ADDENDUM NO. 2

South Walnut Street (Winslow to Ridgeview) Sidewalk Project

Issue Date: December 16, 2021

SITE LANDSCAPE PLAN

C701

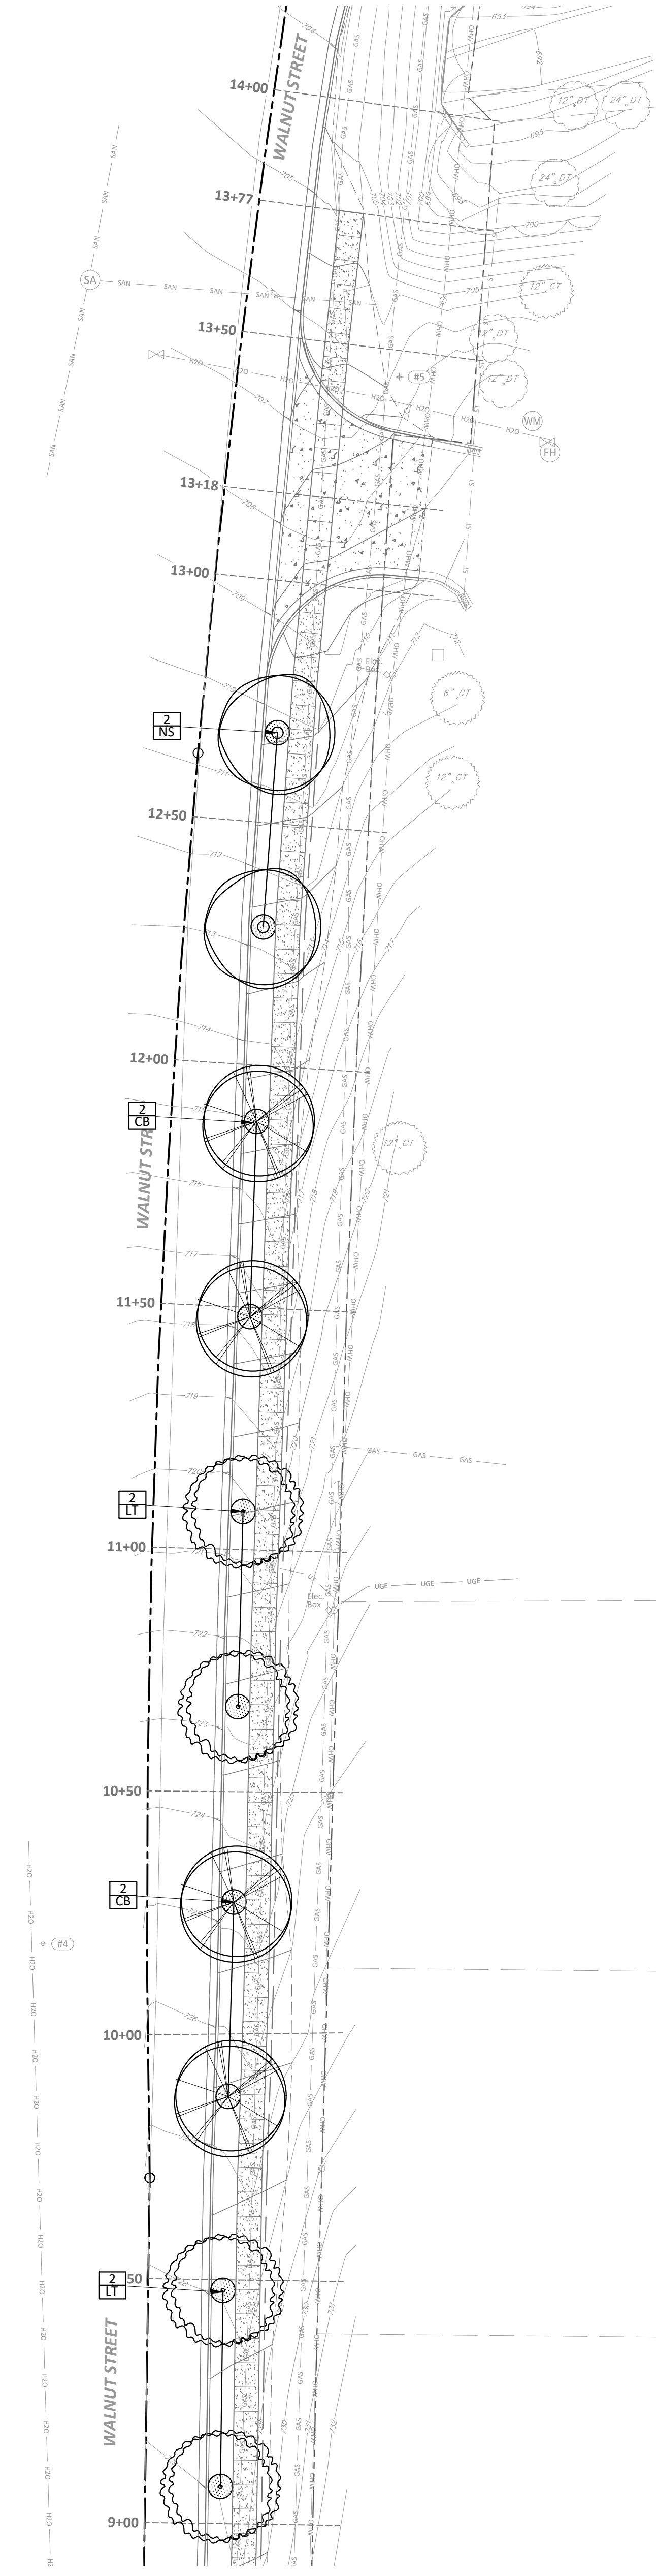
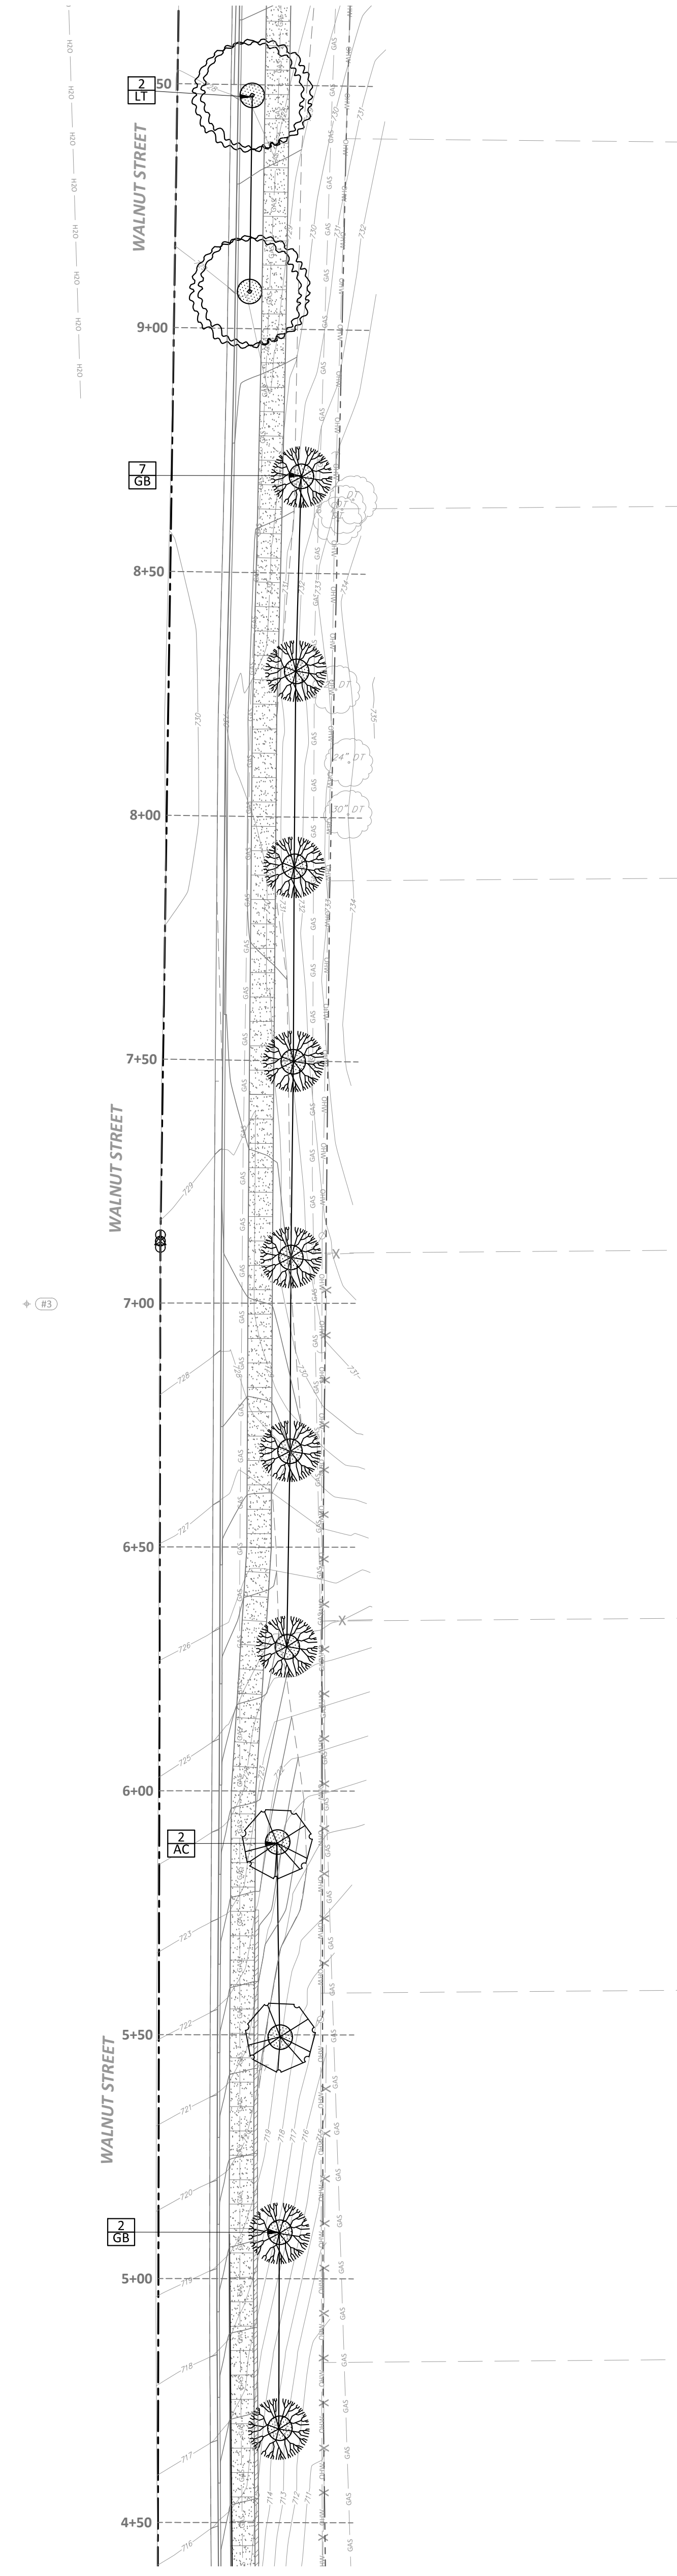
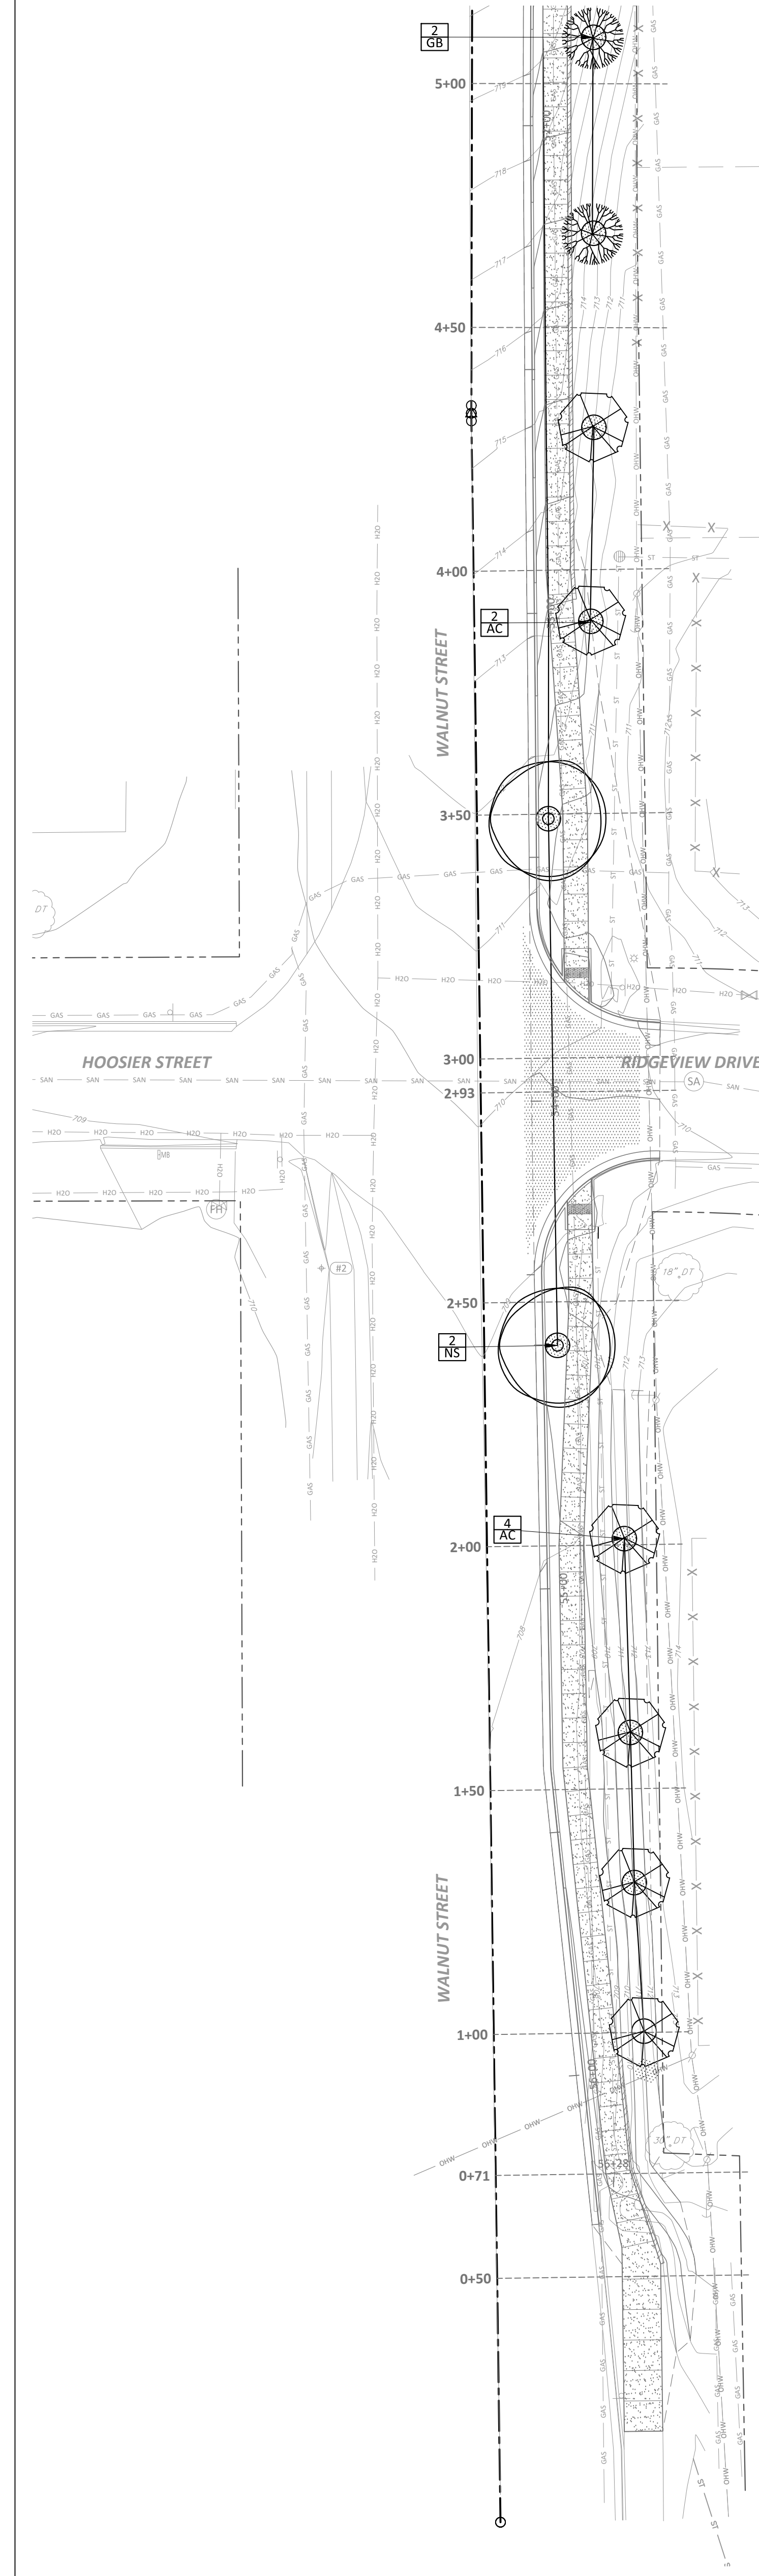
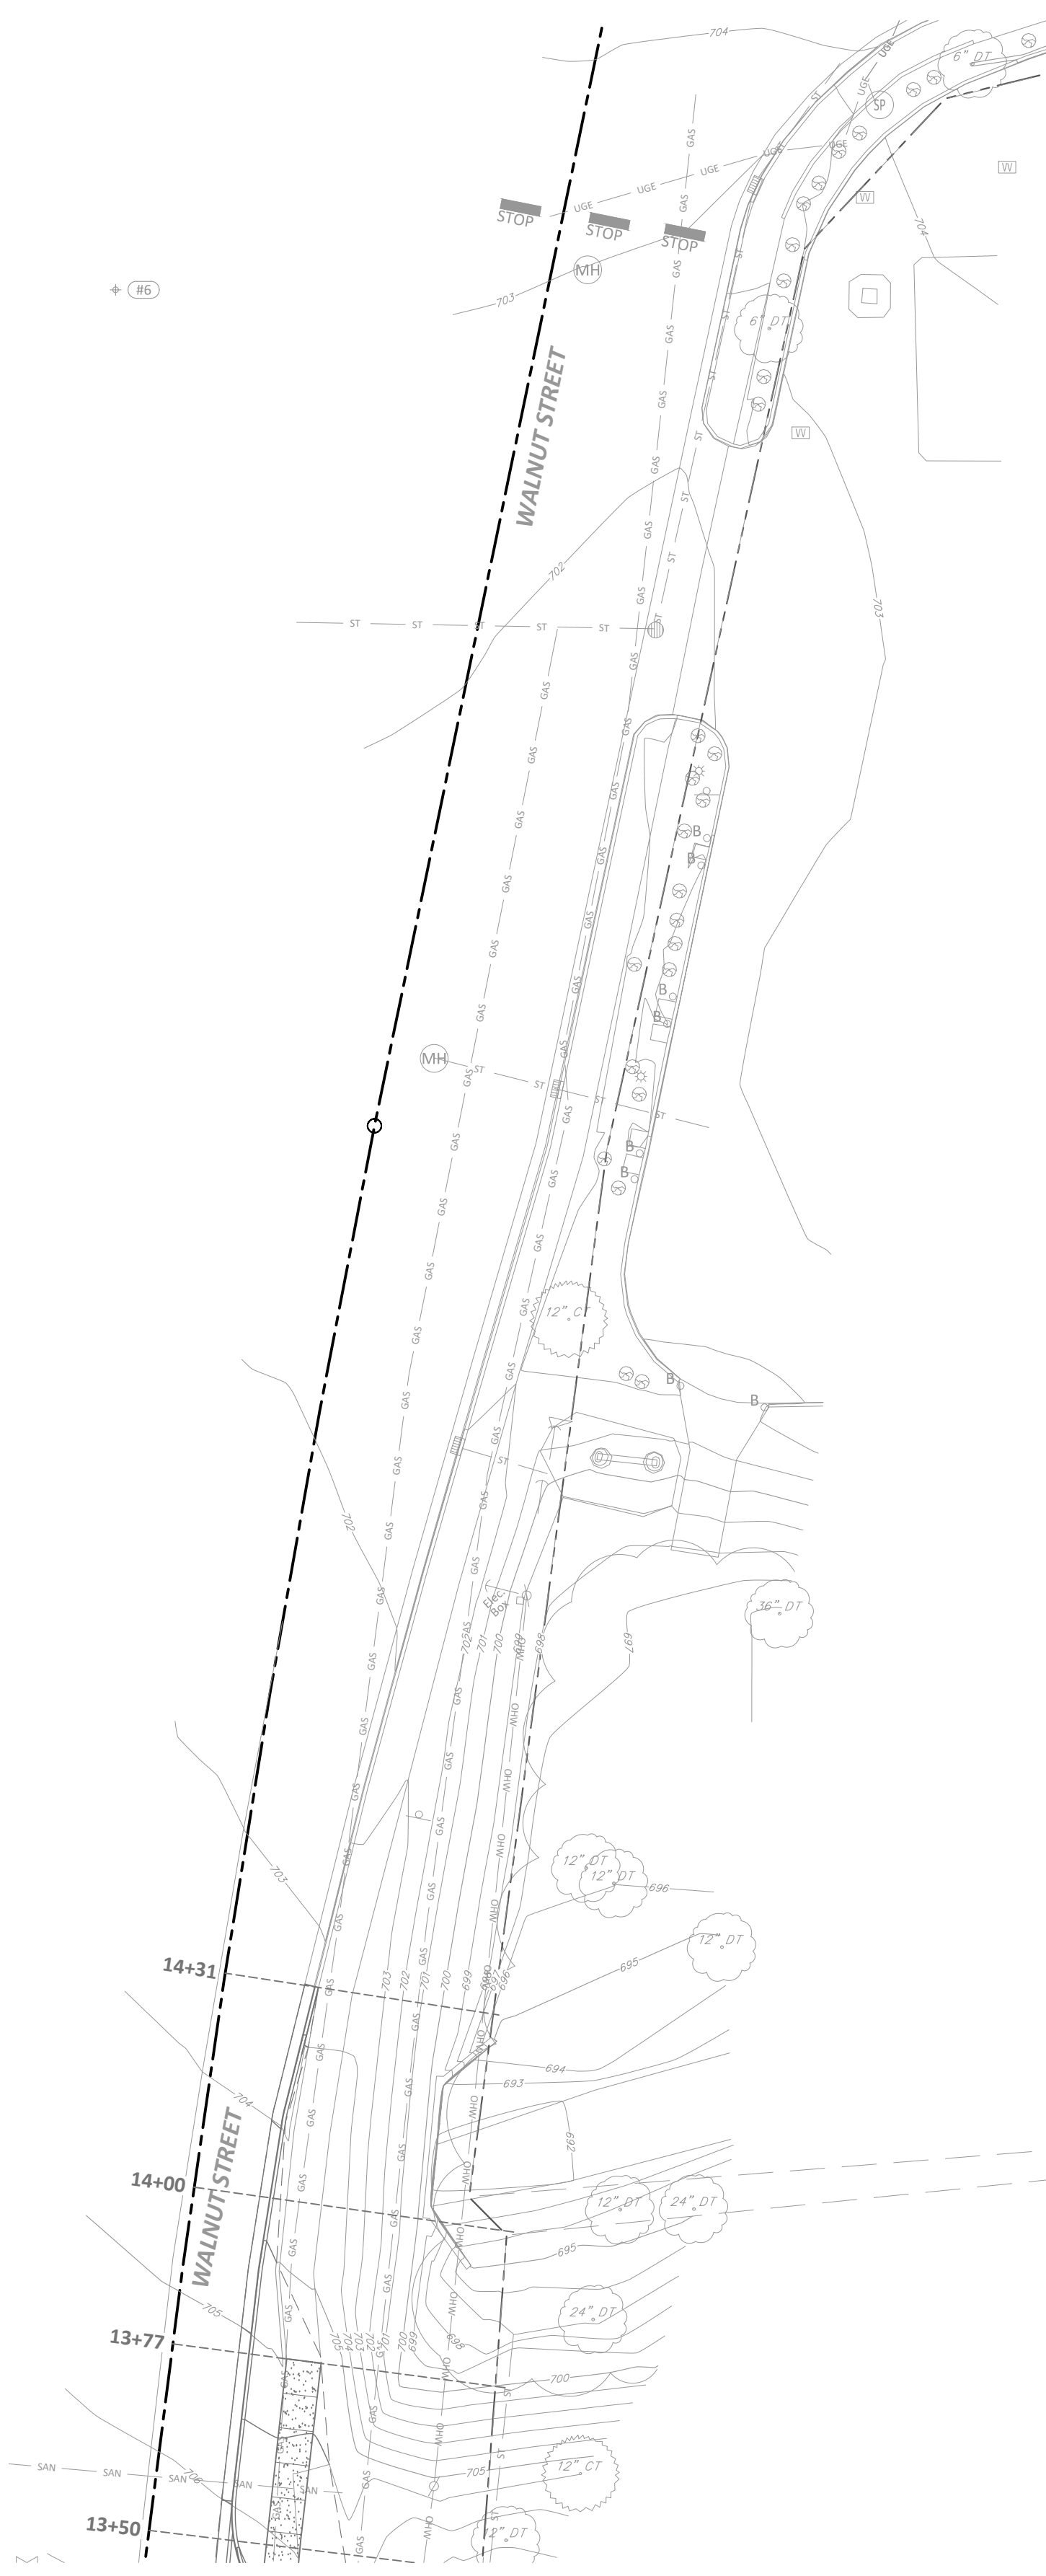
(Q) I wanted to pass along that there are deltas between the plant schedule and the actual plan count on the landscape plan, sheet C701.

(A) Bidders shall use the previously provided quantities shown in the Unit Price sheet of the Bid Packet. The City believes that the plant quantities are accurate. Note that the plan sheets have a 50' overlap in stationing which may lead to mistakenly double-counting some trees.
